| Notice of Allowability | Application No. | Applicant(s) | |
| | 10/577,044 | SHIGEMATSU, RYOHEI | |

DETAILED ACTION

Examiner's Amendment

FIG.1

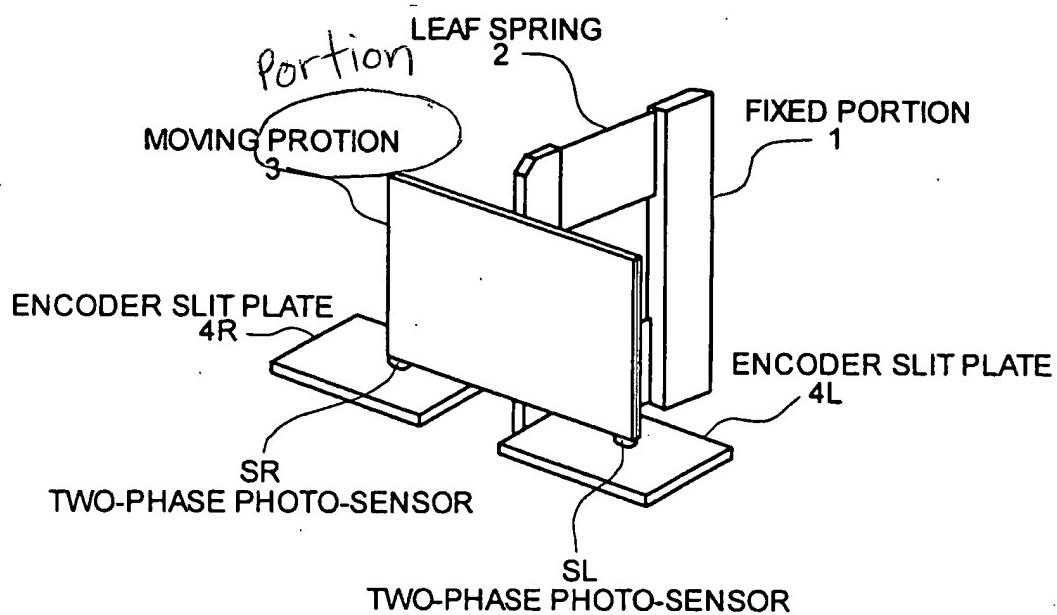
Attachment Markup sheet of Fig. 1, indicates the typographical error to be corrected.
